SUBDIVISION REVIEW SHEET**CASE NO.:** C8-2020-0141**COMMISSION DATE:** February 1, 2022**SUBDIVISION NAME:** Velocity Preliminary Plan**ADDRESS:** 3848 1/2 E SH 71 SERVICE ROAD EB**APPLICANT:** Justin Kramer (Kimley-Horn)**AGENT:** Karl Koebel (Market Place Real Estate Group)**ZONING:** LI-PDA Limited Industrial**NEIGHBORHOOD PLAN:** None**AREA:** 24 acres**LOTS:** 19**COUNTY:** Travis**DISTRICT:** 2**WATERSHED:** Onion Creek**JURISDICTION:** Full Purpose**SIDEWALKS:** Sidewalks will be constructed along Side Park Commons, World Drive, Velocity Crossing, Sprit Drive, S FM 973 Rd, E SH 71 EB, Toll 130 and Monument Way.**VARIANCE:** None requested**DEPARTMENT COMMENTS:**

Staff recommends disapproval of the plan for the reasons listed in the comment report dated January 27, 2022, and attached as Exhibit C.

Exhibit C: Comment report dated January 27, 2022

**CITY OF AUSTIN –DEVELOPMENT SERVICES DEPARTMENT
SUBDIVISION APPLICATION – MASTER COMMENT REPORT**

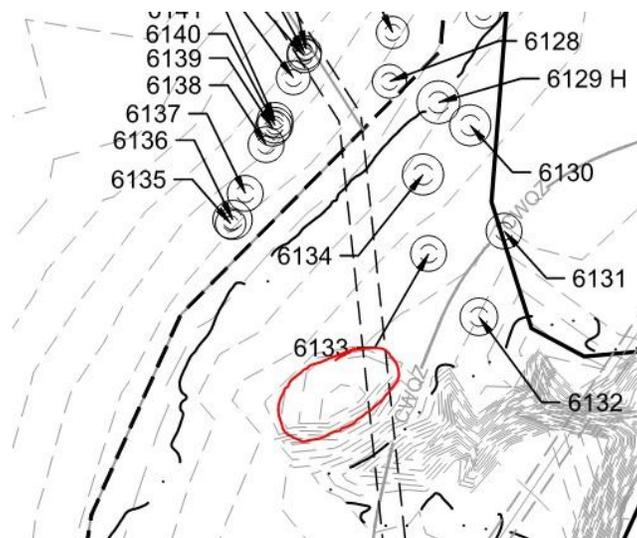
WB1. One or more CEFs are not accurately shown [ECM 1.10].

Staff has identified a wetland Critical Environmental Feature on site. Delineate on the plan and label as WETLAND CEF.
